Civil Engineering Impacts on Existing Tree Cover

**Hammond Ground, Read in respect of
Application No. 3/2026/0356**

**For the erection of 77 no. dwellings and creation of
community parkland with vehicular access from Whalley
Road and associated infrastructure, parking and landscaping**

Technical Working Notes – Earthworks, Trees and Enabling Works

Example 1 – Highway Section Adjacent to Retained Tree

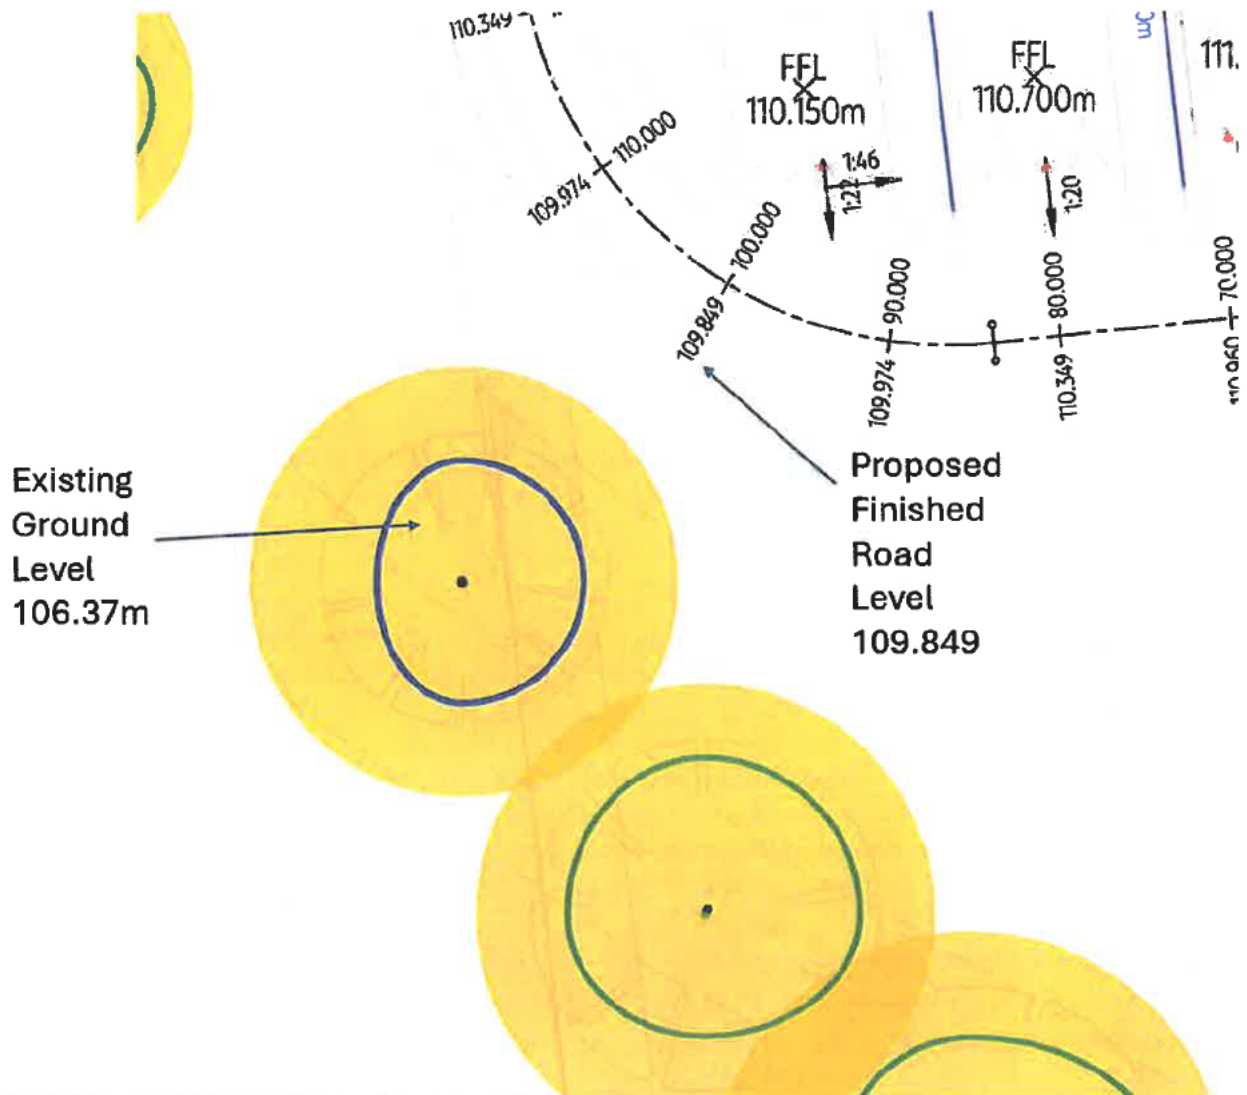
- The highway section indicates approximately **3 metres** difference between the existing and proposed ground levels.
- The adjacent External Works drawing shows a retained mature tree within close proximity to these proposed works.
- The submitted drawings also indicate that existing ground levels around retained trees should remain unchanged.
- Based on the information currently submitted, I cannot reconcile how these proposed earthworks can be undertaken whilst maintaining the existing ground levels around the retained tree.
- Additional engineering and arboricultural detail would help explain how this constraint is intended to be managed.

How can the proposed changes in ground levels be achieved whilst maintaining the existing ground levels around this retained tree, as indicated elsewhere on the submitted drawings?

Proposed new junction overlaid on to existing TOPO survey

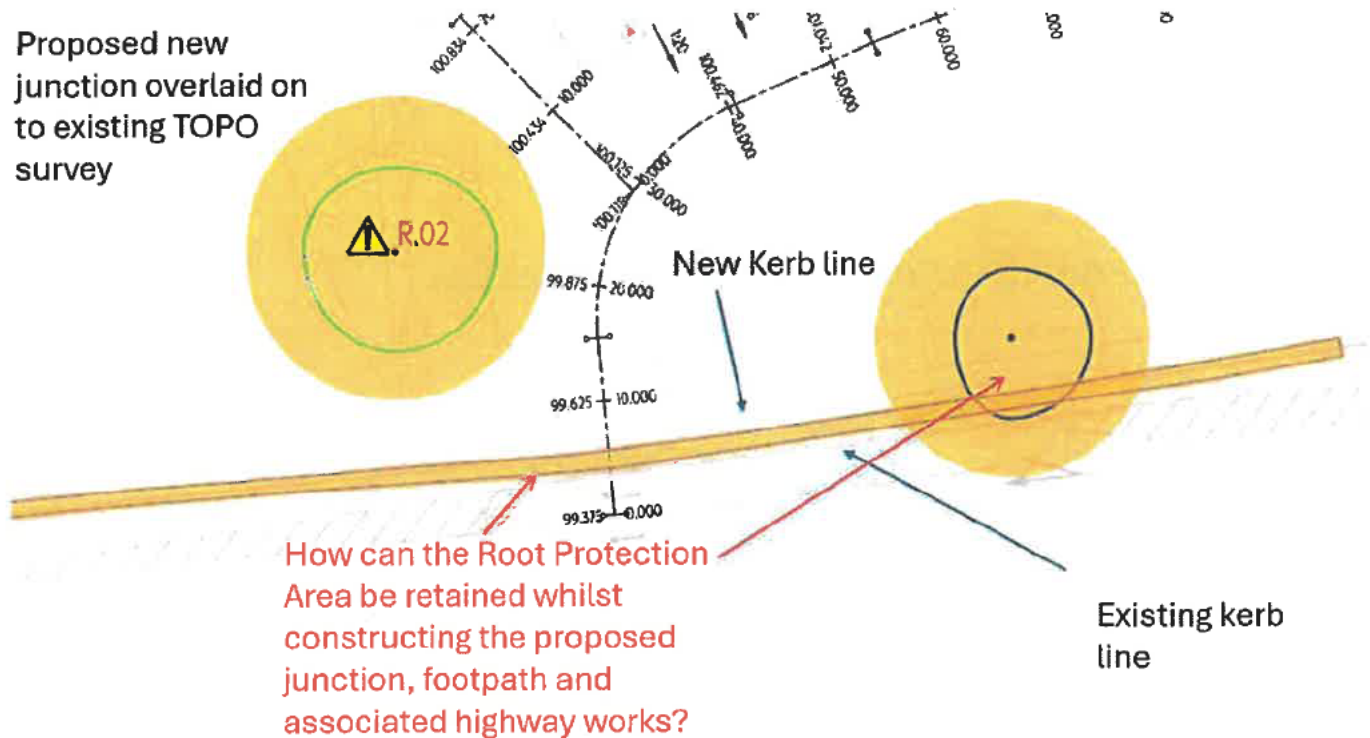
- The proposed highway junction appears to be located immediately adjacent to the retained mature trees, with parts of the proposed road and footpath extending into, or immediately alongside, the Root Protection Areas shown on the submitted drawings.

- The Root Protection Area also extends beneath the existing hedge line, yet the proposed junction appears to require the removal of part of the existing boundary and hedge to accommodate the revised highway layout and required visibility splays.

- I understand the applicant has now indicated that a substantial section of the existing boundary wall will be demolished and rebuilt further back from the highway. If this is the case, it would introduce additional excavation and construction activities immediately adjacent to the retained trees and their Root Protection Areas.

- Construction of the proposed junction would typically involve excavation, drainage installation, pavement construction, kerb construction, utility diversions (if required), and ground compaction, all within an area identified for tree protection.

- From reviewing the submitted drawings, I have been unable to identify how these engineering works can be undertaken whilst maintaining the Root Protection Areas and protecting the retained trees throughout construction.

- The submitted information also does not explain how temporary works, construction access, plant movements and excavation required to reconstruct the boundary wall would avoid impacting the Root Protection Areas.

How will the proposed highway junction, footpath and associated construction works be delivered whilst protecting the retained trees, their Root Protection Areas and the existing hedge?

Example 3 – Retained Tree Behind Existing George Lane Properties

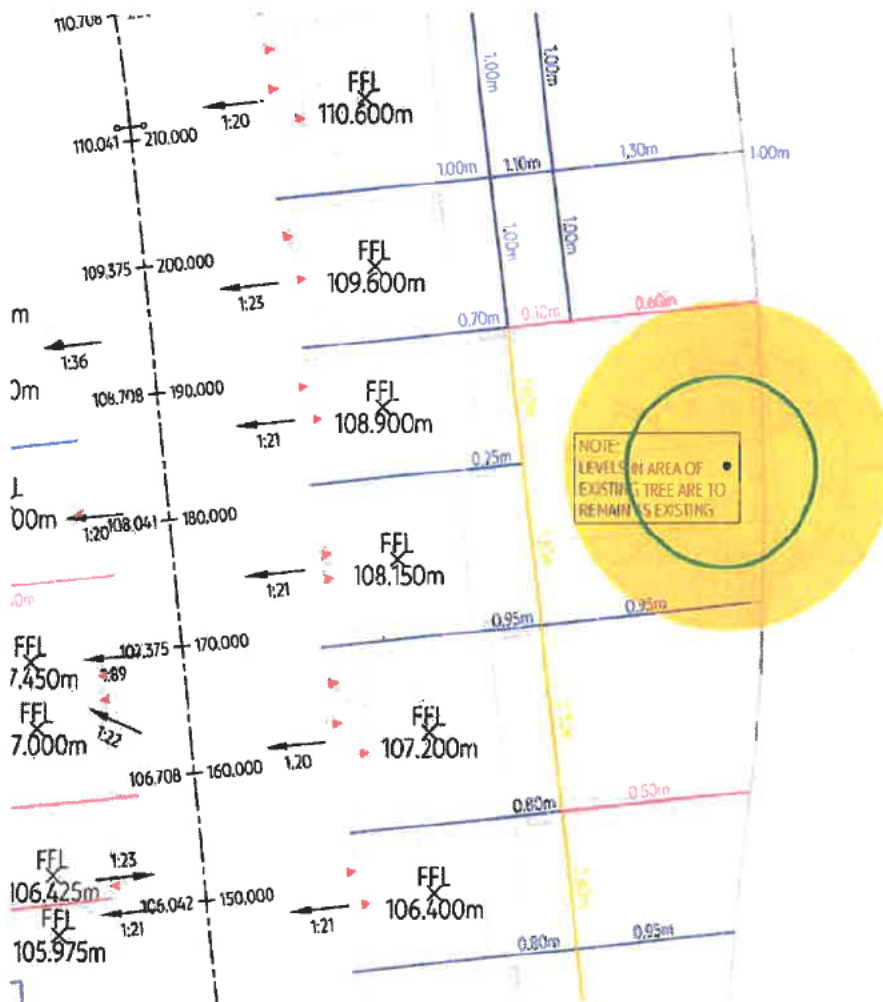
- This retained mature tree appears to remain within an area where substantial regrading of the site is proposed.
- The surrounding drawings indicate retaining walls, changes in finished levels and significant earthworks immediately around the tree.
- Before retaining walls and final levels can be constructed, it is likely that bulk earthworks would first be required to establish the new development platforms.
- From reviewing the submitted information, I cannot understand how those bulk earthworks could be undertaken whilst preserving the existing ground conditions around the retained tree.

- The Designers Risk Assessment identifies **Risk Reference R.02** relating specifically to the existing retained tree.
- The risk assessment states:
 - *"Levels within TPO are lower than the existing road. It is suggested that an arboriculturist is consulted."*
- This indicates that the design team has already recognised that the relationship between the existing tree, surrounding levels and the proposed engineering works requires further consideration.
- However, from reviewing the submitted drawings, it remains unclear how the proposed level changes and associated construction works will be carried out whilst protecting the retained tree and its Root Protection Area.
- The submitted information would benefit from further explanation demonstrating how the engineering proposals and tree protection measures are intended to work together throughout construction.

The designers have identified this tree as a design risk. What engineering and arboricultural measures are proposed to address that risk whilst delivering the proposed level changes?
